Response to Submissions

*SSD-79146716 Pymble Ladies'
College Secondary Innovation
Precinct and Campus Commons*

Figure 1 Tree Retention Setback Plan

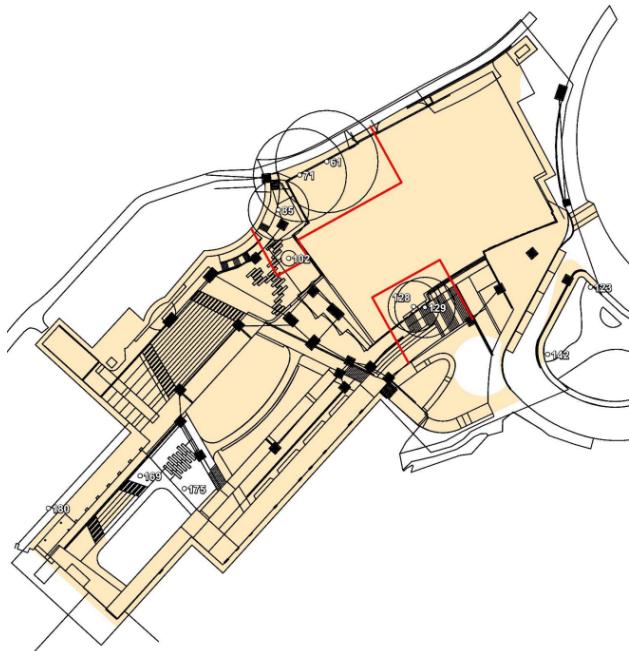
Alternative scenarios involving a reduced building footprint have also been explored in order to retain Trees 61, 71 and 85, however this would entail extensive building redesign which would not achieve the project goals or intended design outcome. A Tree Setback Plan (see **Figure 1**) has been prepared by Tree Survey which demonstrates the extent of the encroachment of the Tree Protection Zones / Nominal Root Zones of these trees by the proposed building footprint. Retention of these trees, as well as additional trees identified

Figure 1 shows that the redesign of the SIP to retain trees 61,71 and 85 would be impractical and would not deliver the functional, safety, and environmental outcomes essential to the

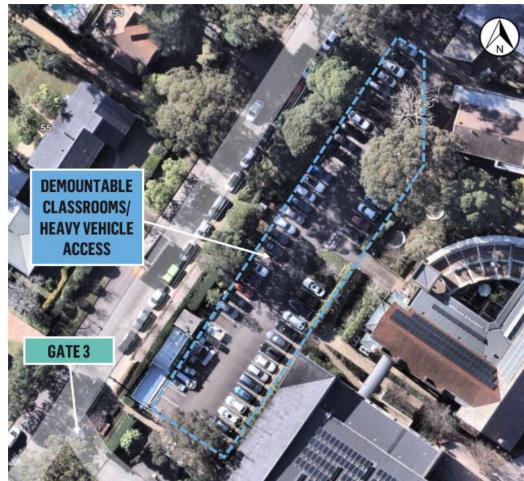
<p><u>Cumulative Impact Assessment</u></p> <p>The EIS states that approximately 14 temporary demountable structures will be required within the school site to</p>	<p>The EIS identified that it was likely that an exempt development pathway would be used for the proposed temporary demountables. Additional analysis has subsequently been undertaken to understand the space required to accommodate the number of students that will be temporarily displaced by the demolition of buildings for the SIP. This has shown</p>	Appendix G, J & K

Summary of Issue Raised	Response	Supporting Document
<p>accommodate displaced students during construction of the SIP, delivered under an exempt development pathway. However, no details have been provided regarding their proposed location/s, access and servicing arrangements, or their impacts on traffic, amenity, or biodiversity.</p> <p>The Department's Cumulative Impact Assessment (CIA) Guidelines specify that cumulative impacts include 'reasonably foreseeable activities necessary for project delivery'. Reliance on the exempt development pathway does not remove the need to assess the siting and associated impacts of the temporary demountable structures in this application.</p> <p>The RtS must:</p> <ul style="list-style-type: none"> • identify the location/s of temporary demountables on a revised site plan • assess their impact on traffic, access, parking, biodiversity/tree removal • update relevant reports to address the temporary works and structures. 	<p>that two storey demountables are likely to be required, with their installation to be subject to a separate local DA to Ku-ring-gai Council.</p> <p>Notwithstanding, the project team has reviewed the area that will be occupied by the demountables. They will be located on the existing Conde staff carpark, located close to Avon Road on the northern part of the campus. The carpark is sealed bitumen with no vegetation either planted or remnant that will be affected by the proposal. A possible layout of the demountables is shown in the aerial image below. The Conde carpark is located close to the existing Conde Library and Senior School Centre. The location is readily accessible via existing pathways with no additional works required to support the demountables. Staff and students that occupy the demountables will remain well integrated with the Campus meaning that once installed there will be minimal operational impacts to the school.</p> <p>Figure 4 Proposed Demountable Location – Conde Carpark</p>

Figure 5 Development Area

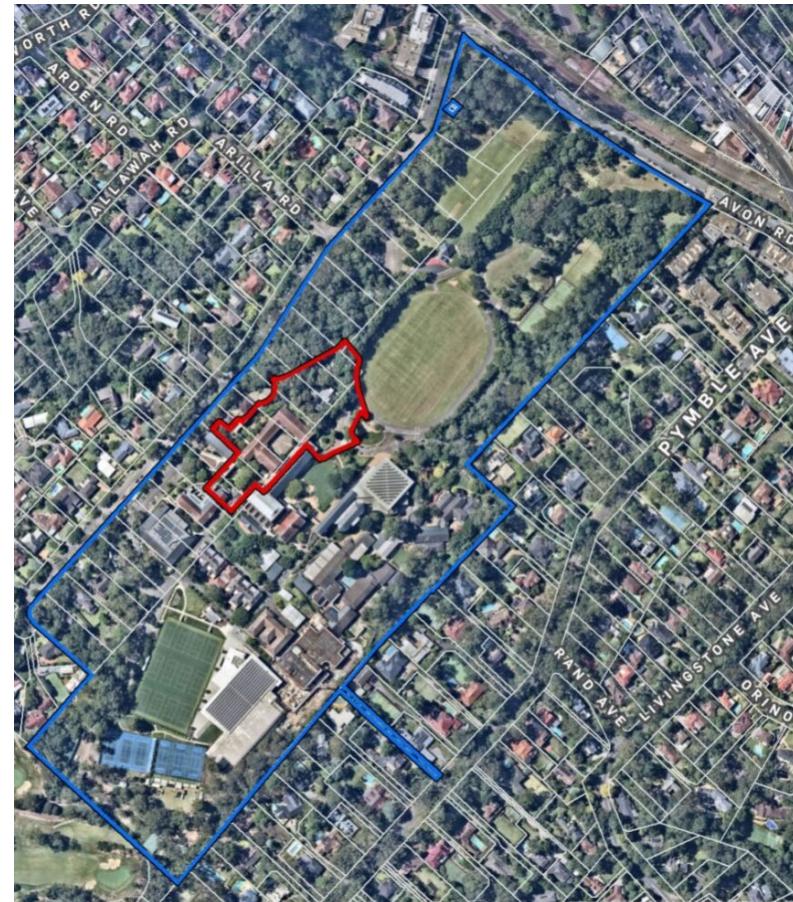
<p>The RTS must:</p> <ul style="list-style-type: none"> clearly identify the land to which the development relates (the site), and provide consistent terminology across all documents where documents have distinguished between the "development area" and broader site, this must be consistent across all technical documents confirm that all relevant environmental and amenity impacts have been assessed 	<p>There are some ancillary elements of the proposal including supporting parking located outside of the development site, and where this is relevant to a technical assessment this has been made clear. The BDAR addresses all potential impacts within the development site as well as considering potential impacts outside of this area relating to construction parking. However, we note that the terminology used to describe the site and the context in the BDAR is prescribed by the <i>Biodiversity Conservation Regulation 2017</i> so this report refers to the 'subject land.'</p> <p>This approach has been applied throughout the reporting updated as part of this RTS.</p>

for the extent of area where physical works are occurring (including under a separate planning pathway), and ensure that all technical documents (for instance, a revised BDAR) are updated to reflect this.
